### **Addendum 2: United Nations Global technical regulation No. 2**

**United Nations Global Technical Regulation on measurement procedure for two-wheeled motorcycles equipped with a positive or compression ignition engine with regard to the emissions of gaseous pollutants, CO<sub>2</sub> emissions and fuel consumption**

# **Final report on the development of Amendment 5 to UN GTR No. 2 on the measurement procedure for two- and three-wheeled vehicles equipped with a positive or compression ignition engine with regard to the emissions of gaseous pollutants, CO<sub>2</sub> emissions and fuel consumption**

Figure A1/7

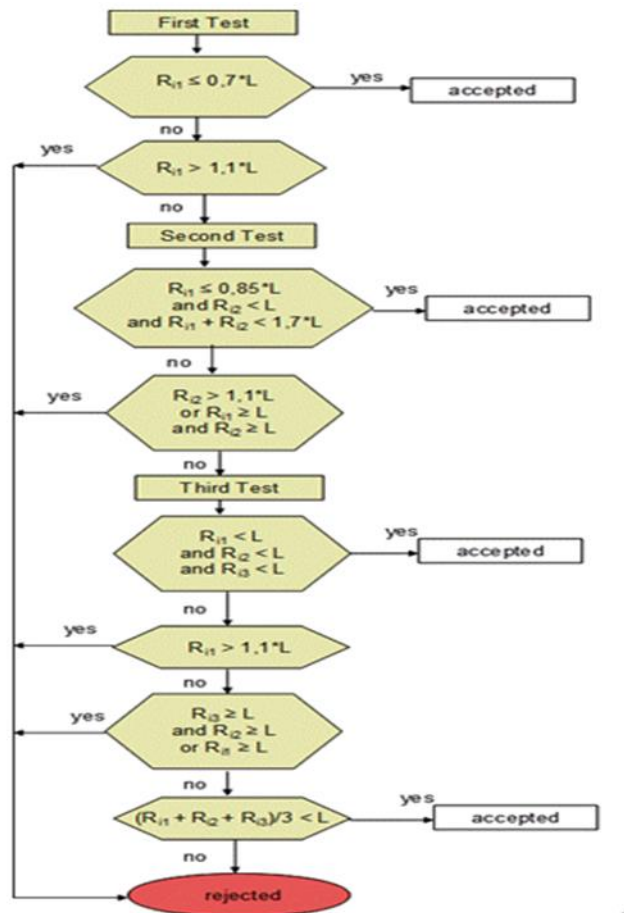
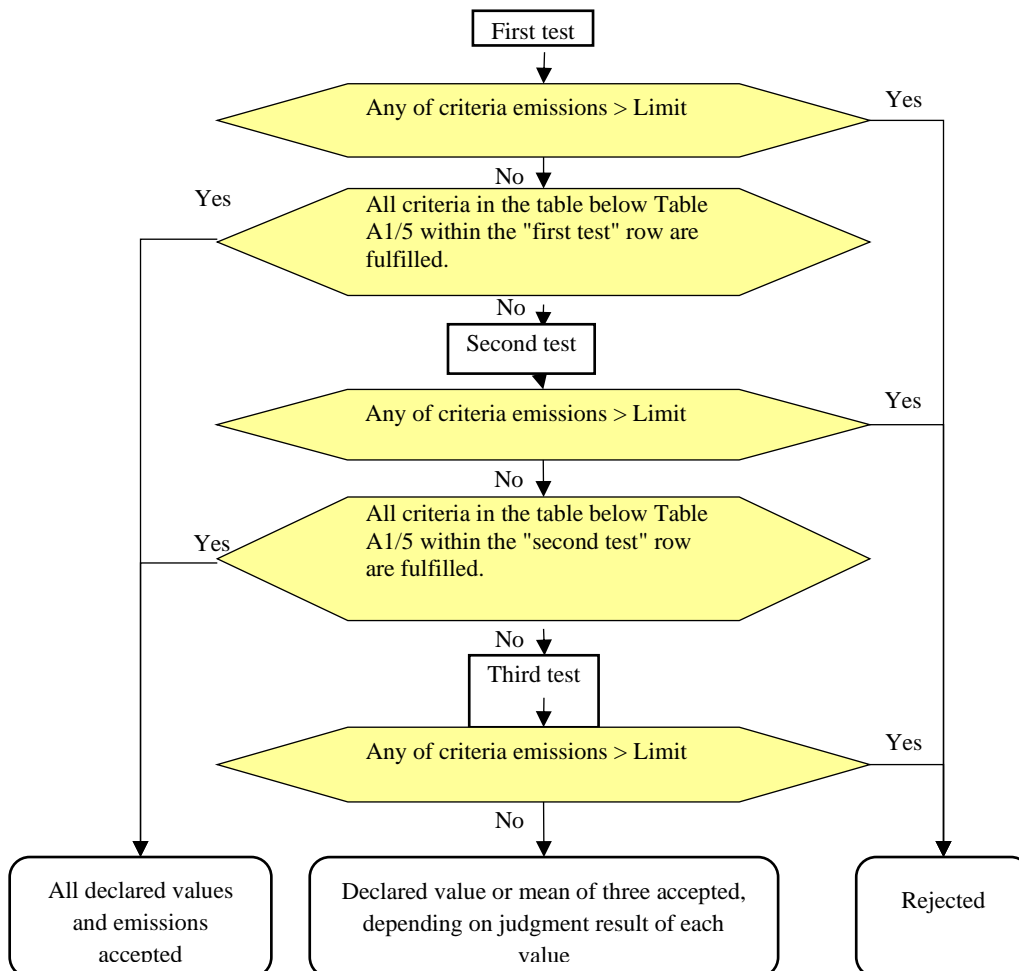
30. In EPPR-43-05 (March 2021), IMMA proposed to substitute the flowchart Figure A1/7 in Amendment 4 with the flowchart Figure A6/1 from the UN GTR No. 15 on WLTP (ECE/TRANS/WP29/2020/127), in order to align it with WLTP.

31. The main difference with the previous flowchart was the correction of the references: from table A5/1 to A6/2.

India/ Kumbhar observed that "declared value or mean of three" was meant for CO<sub>2</sub> and pollutant emissions in UN GTR No. 15, but that this interpretation was not applicable to UN GTR No. 2, not addressing CO<sub>2</sub>.

EPPR-46 (June 2021), the IWG on EPPR agreed to re-check the above flowchart in EPPR-46-06, notably the need or not to have the third test for pollutant emissions. Counterproposals to be sent in written form, in good time to be evaluated by the IWG on EPPR, before following meeting of the IWG on EPPR.

In EPPR-47 (July 2021), The secretariat of the IWG on EPPR invited the IWG to express position on the flowchart Fig. A1/7 in EPPR-46-06, notably on the need or not to have the third test for pollutant emissions.

China had requested at last EPPR-46 session whether the third test was needed for pollutant emissions.

China recalled their request at last EPPR-46 session to check whether the third test was needed for pollutant emissions.

In lack of counter-proposals, the flowchart in EPPR-46-06 remained as in Figure A1/7, noting that the third test applied only to pollutant emissions in UN GTR No. 2.
